**SAN ANTONIO WATER SYSTEM
LIFT STATION ELIMINATION PHASE II – LIFT STATION NO. 217 PROJECT
SAWS PROJECT NO. 09-2507
SOLICITATION NO. CO-00039**

ADDENDUM NO. 2

December 21, 2015

LIFT STATION ELIMINATION PROJECT PHASE II LS-217
SHEET
CONSTRUCTION SEQUENCE PLAN

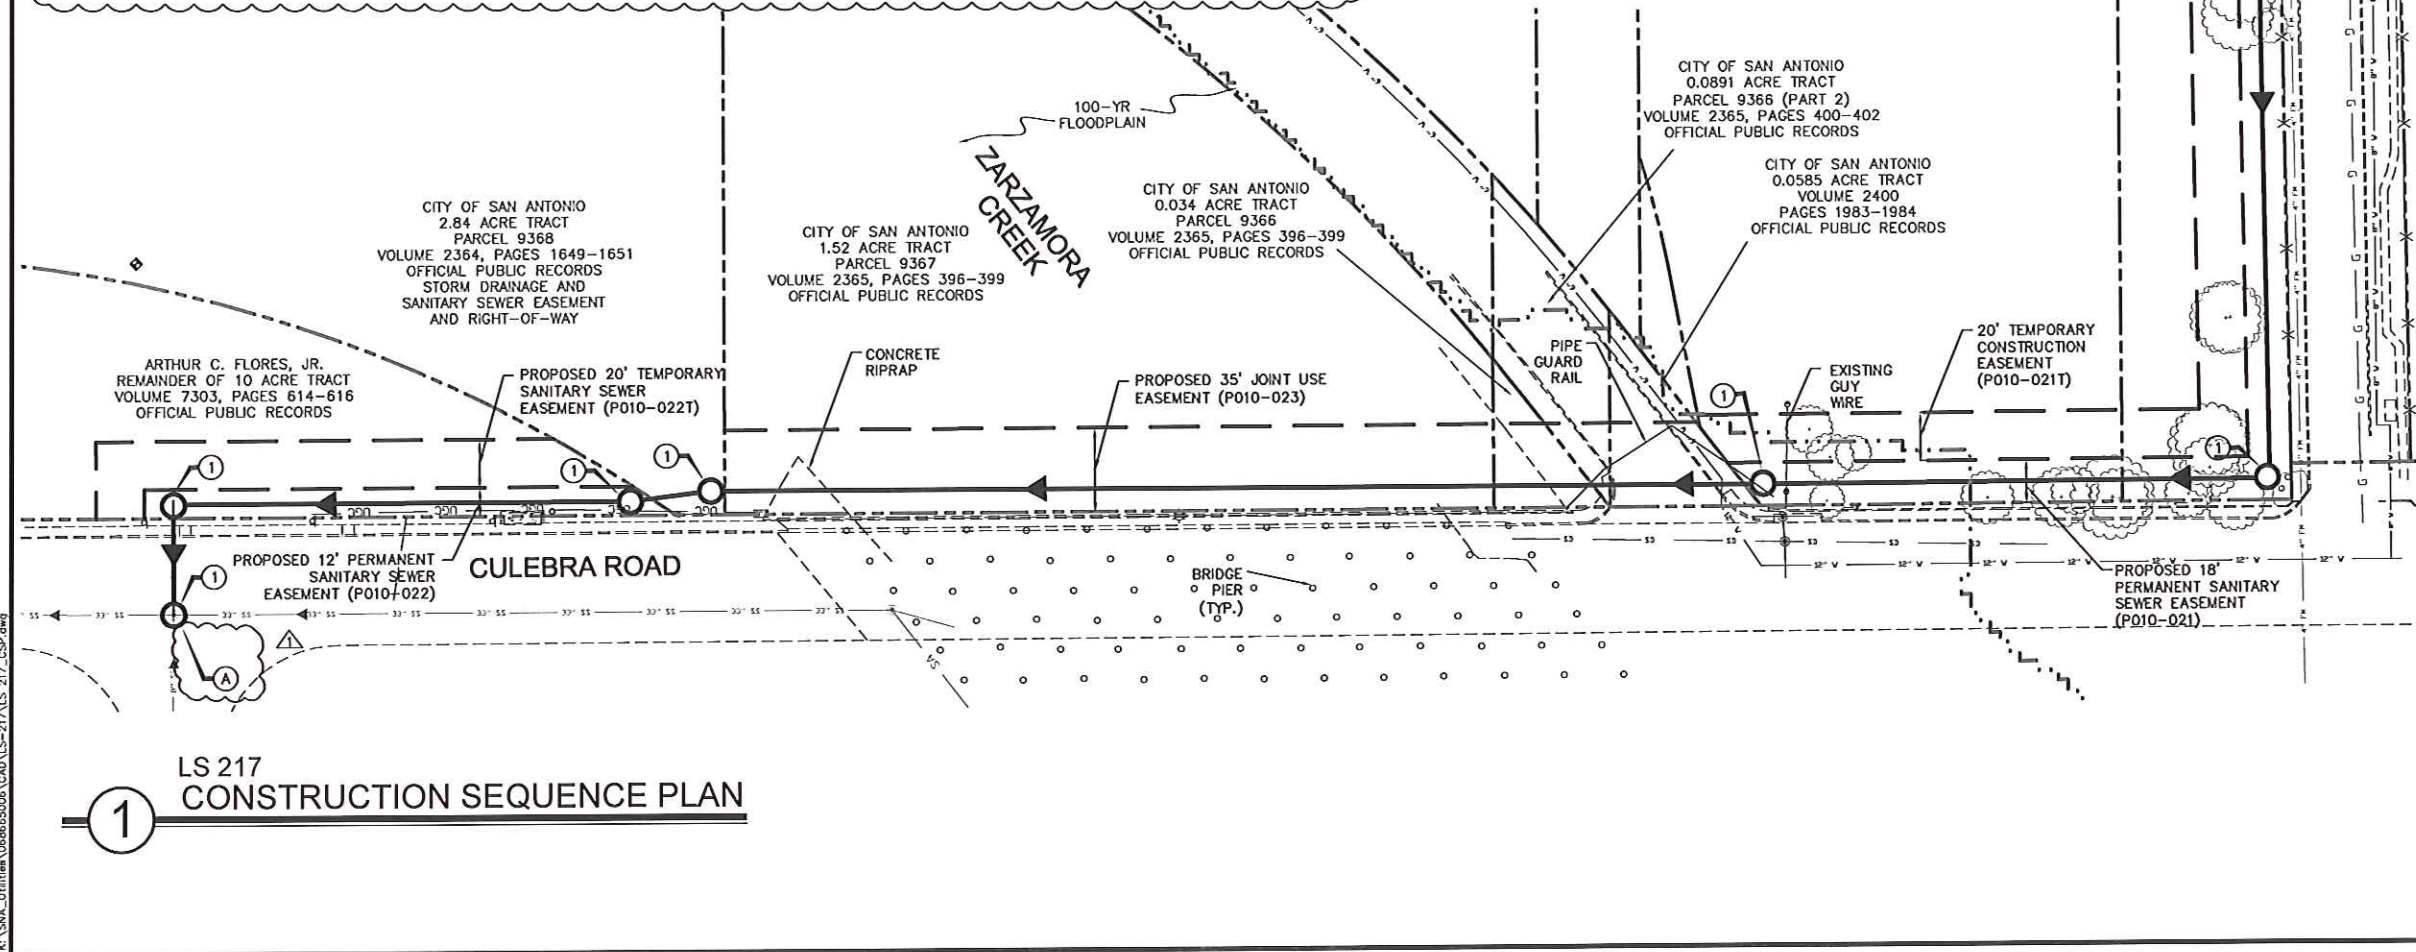
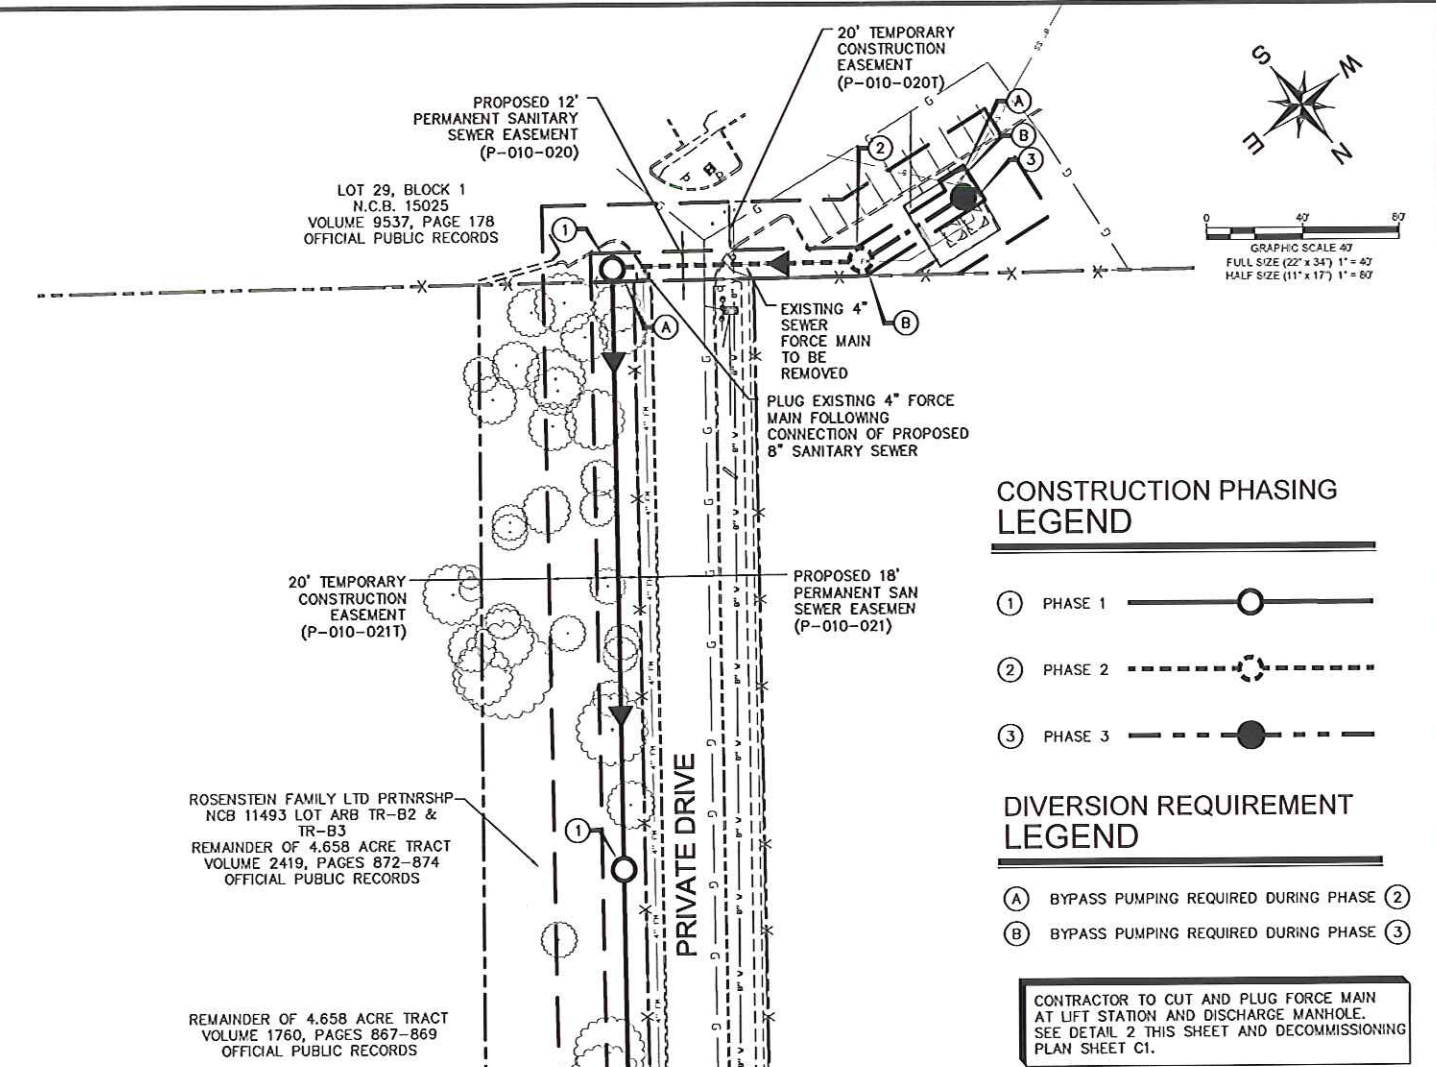
- A. REPLACE – General Notes Sheet G2 with revised attached Sheet G2.
- B. REPLACE – Construction Sequence Plan Sheet G4 with revised attached Sheet G4.
- C. REPLACE – Diversion Gravity Main Plan & Profile 1 of 5 Sheet C2 with attached revised Sheet C2.
- D. REMOVE – Note 7 from Plan & Profile Sheets C2 – C6.

Response:

The abandonment of the force main has been further clarified. Reference Item No. 5B Modifications to Plans of this Addendum for additional information.

CONTRACTOR TO CUT AND PLUG FORCE MAIN AT LIFT STATION AND DISCHARGE MANHOLE. SEE DETAIL 2 THIS SHEET AND DECOMMISSIONING PLAN SHEET C1.

DIVERSION GRAVITY MAIN PLAN & PROFILE 1 OF 5

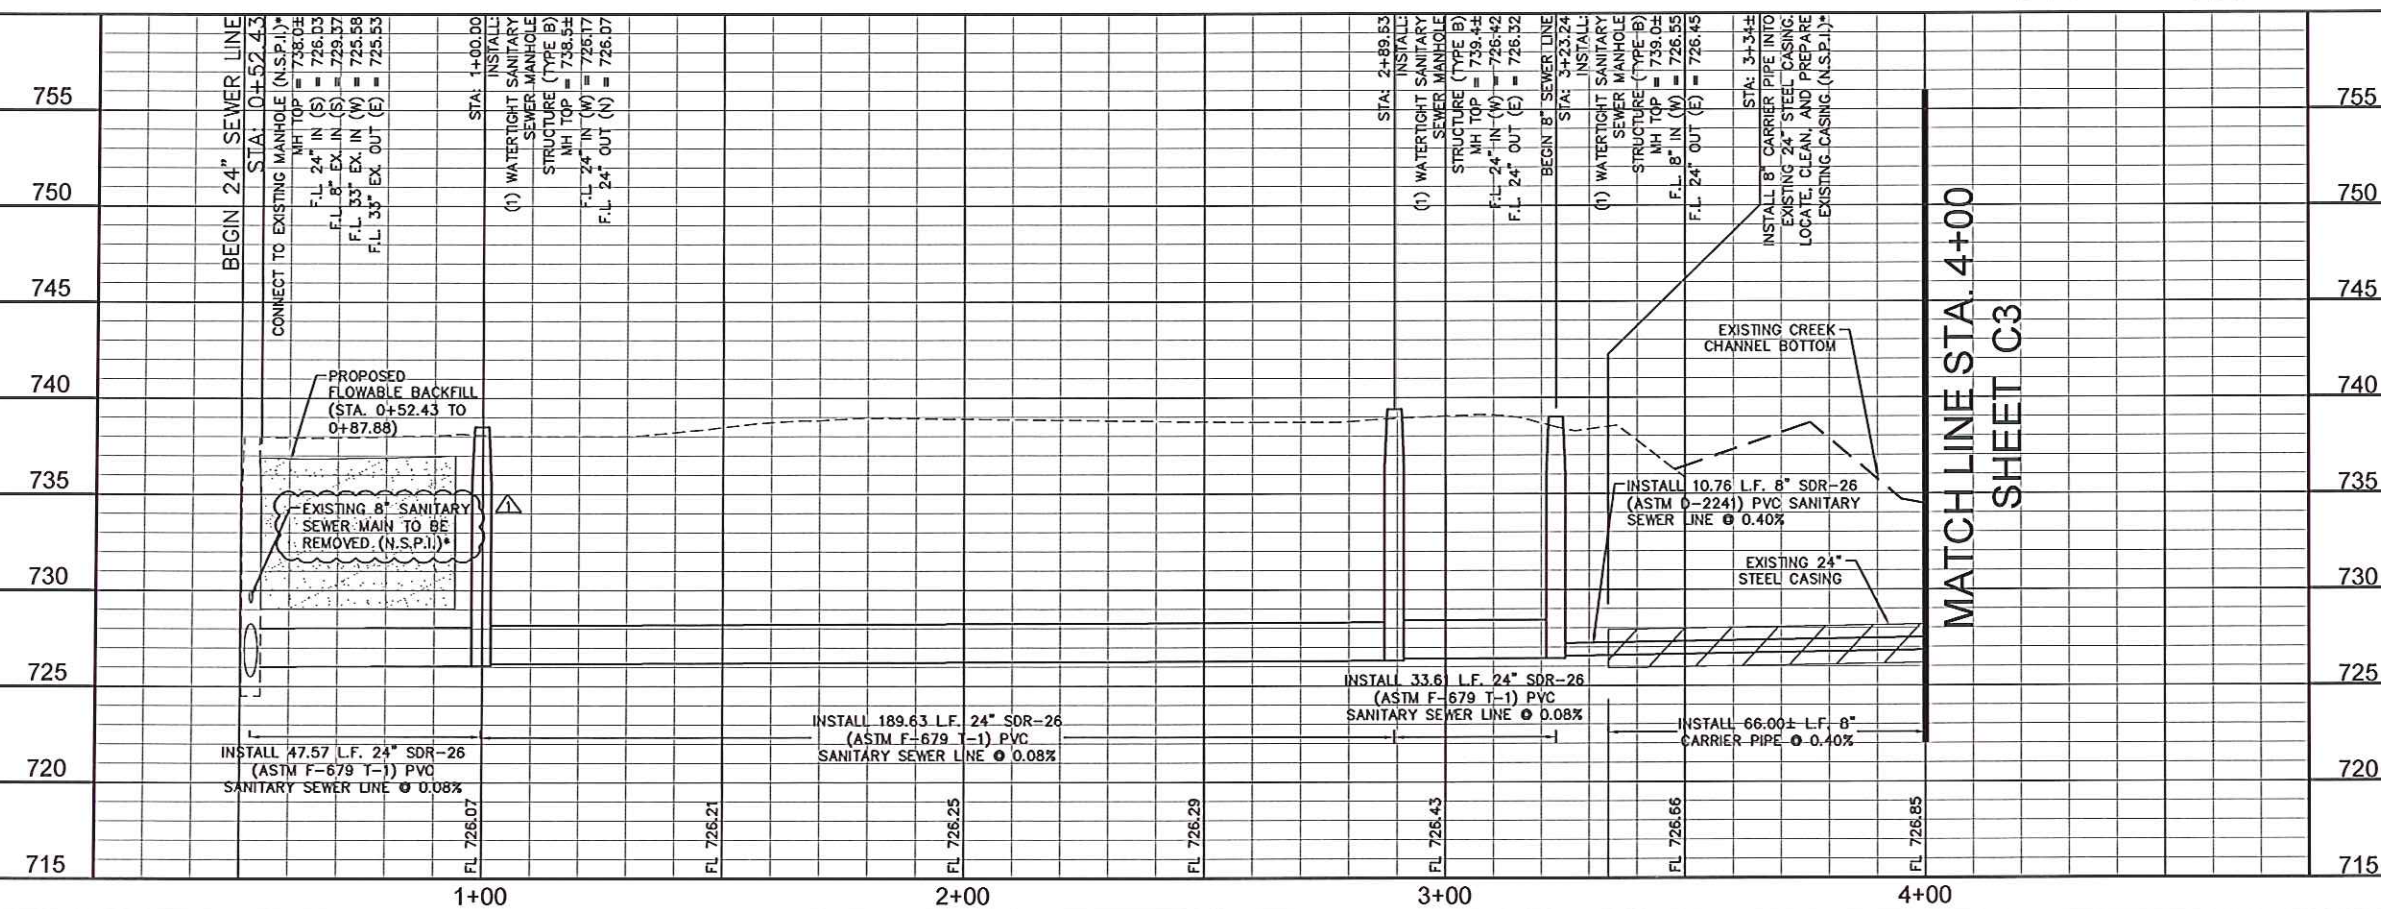
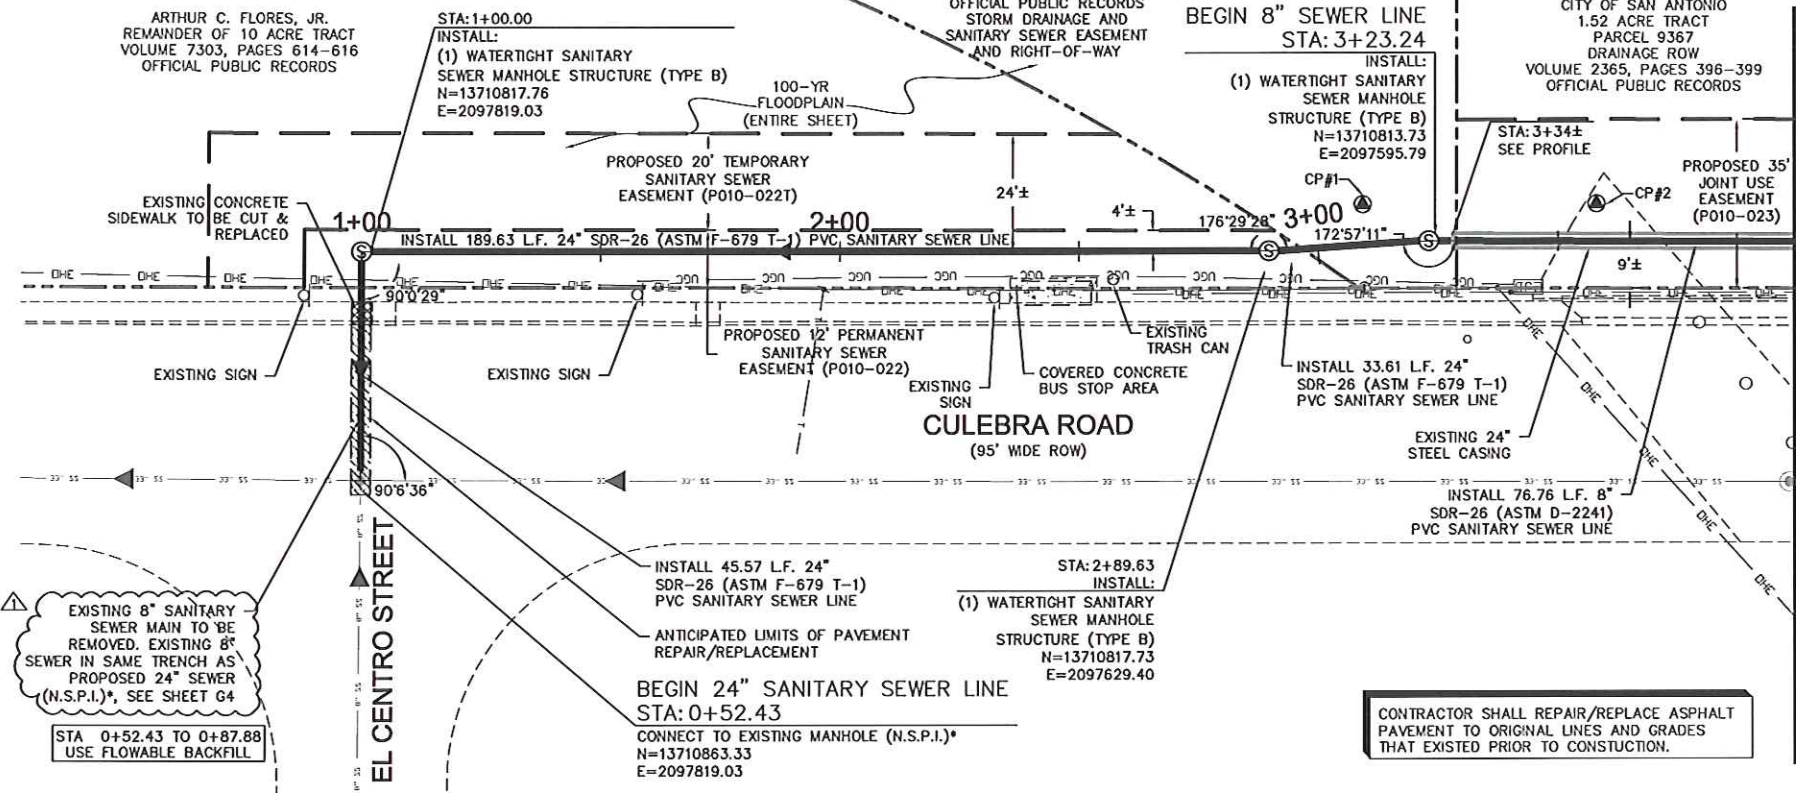
~~“7. Contractor shall submit boring plan to inspector and engineer for review and approval. (N.S.P.I.)*”~~
- E. REPLACE – General Details 1 Sheet C18 with revised attached Sheet C18.

At station 0+52 the plans show to abandon existing 8” sewer main on the profile sheet. Is this the 8” line going south on El Centro Street? If it is not then where is it located?

8” sanitary sewer line to be removed is located south of existing manhole Sta. 0+52.4. Sewer line is located within same alignment as proposed 24” sanitary sewer line from Sta. 0+52.43 – Sta. 1+00. This sewer main removal has been further clarified in Item No.5 of this Addendum Modifications to Plans.

Bid Item #6 – Flowable fill is intended to be used for the flowable fill quantity on Sheet C2. All other flowable fill quantities are subsidiary to that line item.

**LIFT STATION ELIMINATION
PROJECT PHASE II LS-217**
SHEET
GENERAL DETAILS I

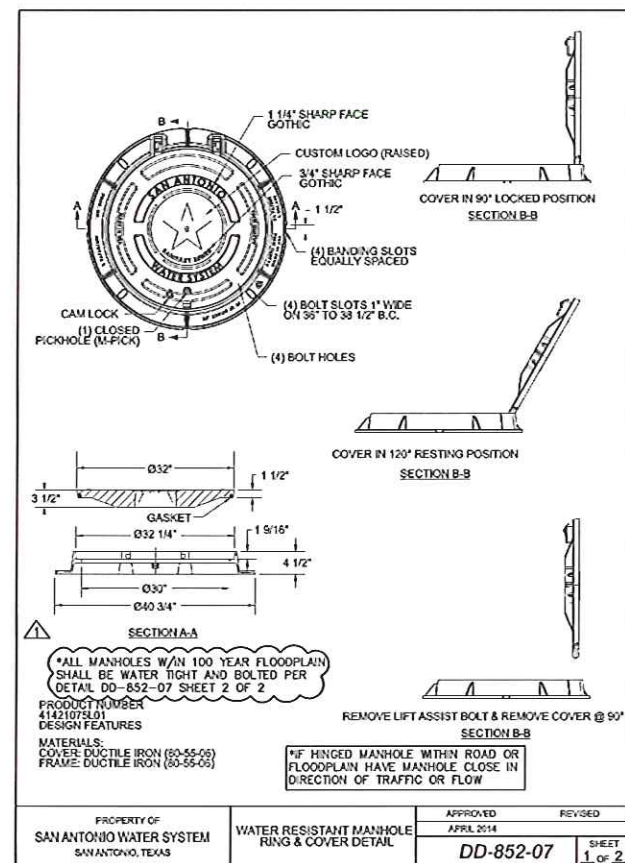
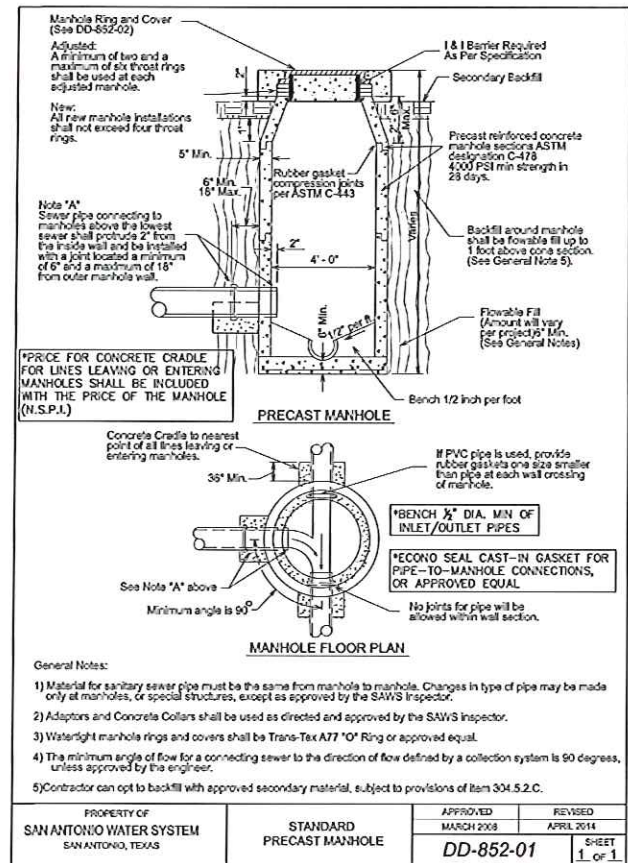
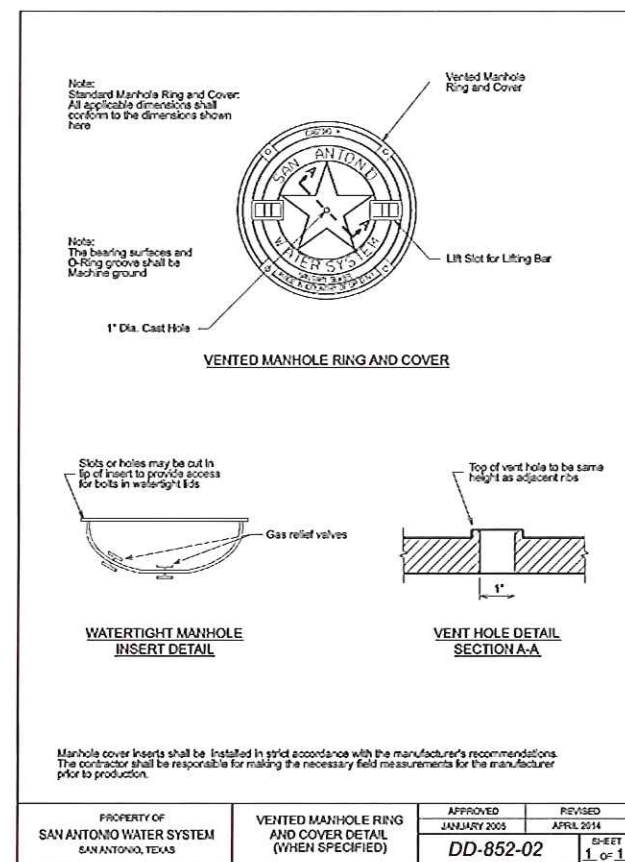
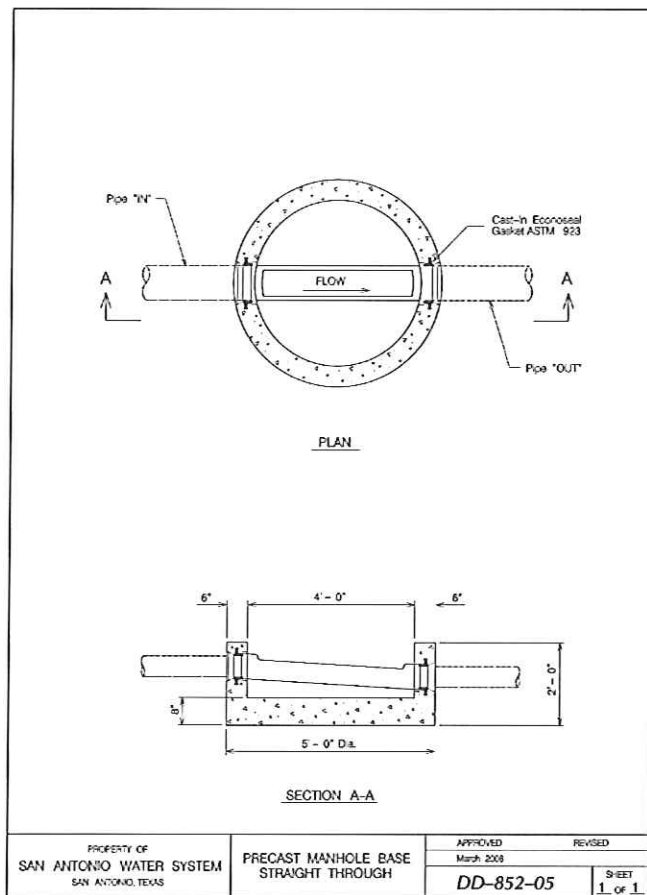
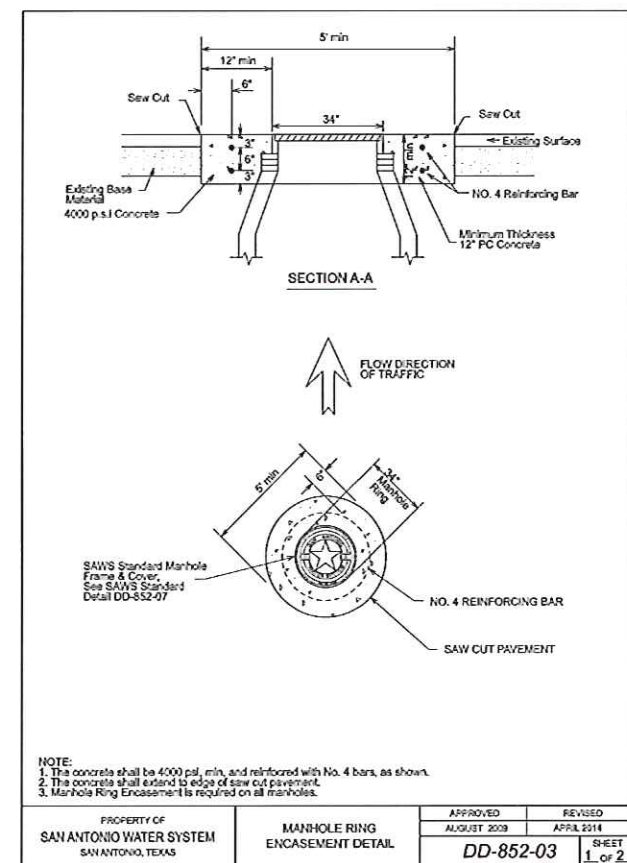
The detail for Manhole ring and covers is for a cam lock water resistant ring and cover, it was mentioned this morning that this project was in the floodplain, for which the specification calls for a water tight bolted down ring and covers. Please confirm we are bidding the correct ring and cover.

Yes, flowable fill is required for all manholes per SAWS detail DD-852-01 on Sheet C18. Flowable fill will be paid by the line item to which it pertains.

All MH's within the floodplain are to be water tight as noted in the Plans. Note has been added to SAWS Standard Details DD-852-07 shown in Sheet C18. Reference Item No. 5E Modifications to Plans of this Addendum for further clarification.

*NOTE: FOR ALL UNPAVED AREAS MANHOLE TOPS SHALL BE 6" ABOVE GRADE.
